## MODEL 2 3 8

### OIL PUMP COMPL.

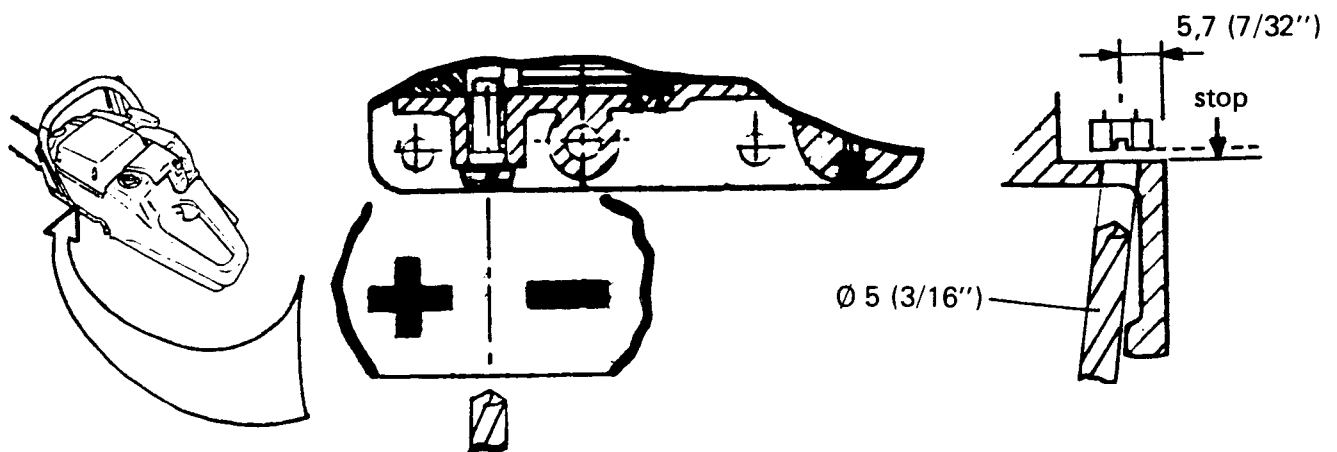
A new adjustable oil pump is introduced, according to below.

The change is introduced from serial number:	238 SE	6240526
	238 SG	6220251

### Basic setting:

For ordinary chain oil: 2 turns open from closed position.

For vegetable oil: 0.5 turns open from closed position.

If necessary, make an individual adjustment.
